INTERIM REVIEW
DOCUMENT INCOMPLETE. NOT INTENDED FOR PERMIT, BIDDING OR CONSTRUCTION.
ENGINEER: JOHN A. TYLER
P.E. SERIAL NO: 105193
DATE: 10/31/2016

CURB RAMP PROGRAM

SPUR ST
SIDEWALK SHEET C

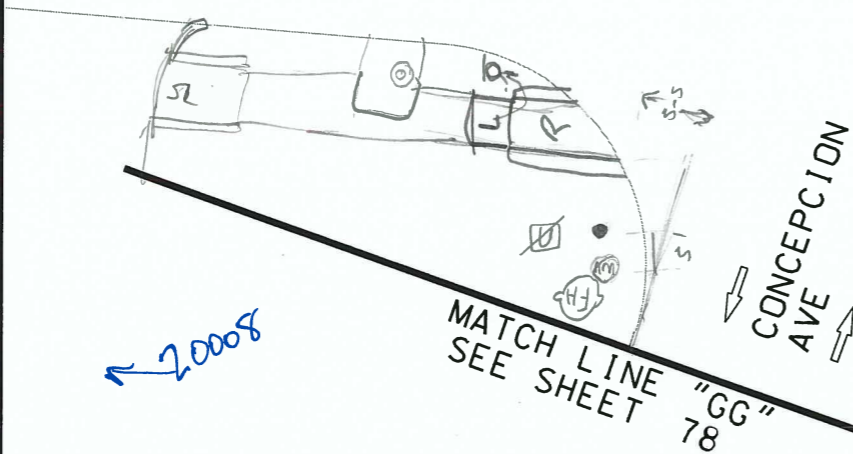
12' ROW?
